Access to OBD information

Information required for the manufacture of diagnostic tools

Japan's concept

Article 5.2.3 [Amendment proposal 2]

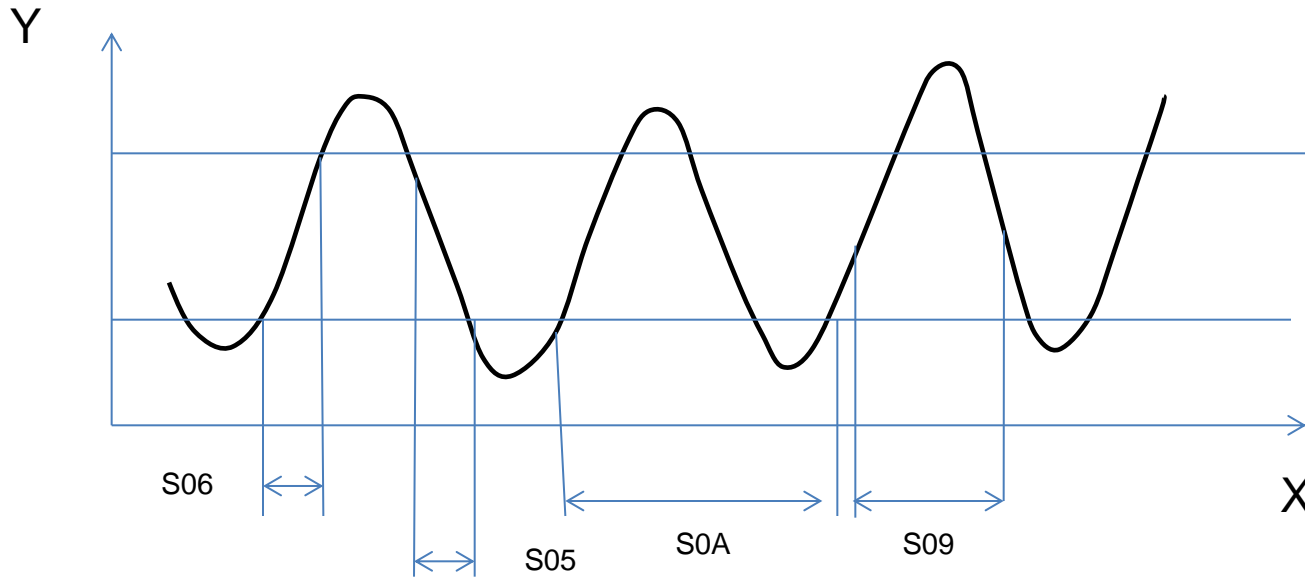
The following are OBDII requirements

\$05: Request oxygen sensor monitoring test results

\$06: Request on-board monitoring test results for specific monitored (e.g. catalyst system)

Example for where each data is monitored
Judge the deterioration by monitoring the signal variation

Delete texts below,

~~“In particular, a comprehensive explanation for the data in service \$ 05 Test ID \$ 21 to FF and the data in service \$ 06 shall be provided. In the case of vehicle types that use a communication link in accordance with ISO 15765-4 ‘Road vehicles — Diagnostics on Controller Area Network (CAN) Part 4: Requirements for emissions-related systems’, a comprehensive explanation for the data in service \$ 06 Test ID \$ 00 to FF, for each OBD monitor ID supported, shall be provided.”~~
